UNITED STATES OF AMERICA
NUCLEAR REGULATORY COMMISSION

McGuire Nuclear Station, Units 1 and 2;

Catawba Nuclear Station, Units 1 and 2

Blue Ridge Environmental Defense League submittal of contentions in the matter of the renewal of licenses for Duke Energy Corporation (DUKE) McGuire Nuclear Stations 1 and 2 [McGUIRE] and Catawba Nuclear Stations 1 and 2 [CATAWBA].

b. Figure 6.1 showing Fragility Curves for all Westinghouse Ice Condenser NPPs:

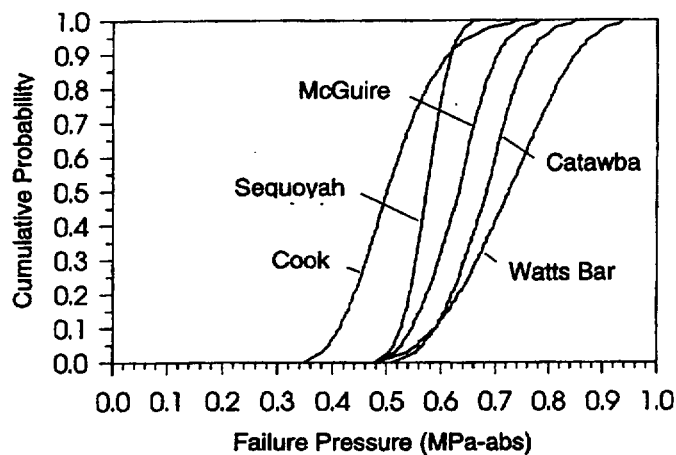
We note that the ice condenser plants are substantially less robust than other Westinghouse plants with large dry or subatmospheric containments. Table 6.1 shows that the mean of the containment failure pressure for all ice condenser plants is 62.8 psig at a failure frequency of 10%. The comparable value for all Westinghouse plants with large dry or subatmospheric containments is 113.1 psig. Ice condenser containments can afford to be less robust because of their reliance on ice beds as a pressure suppression feature for design basis accidents.
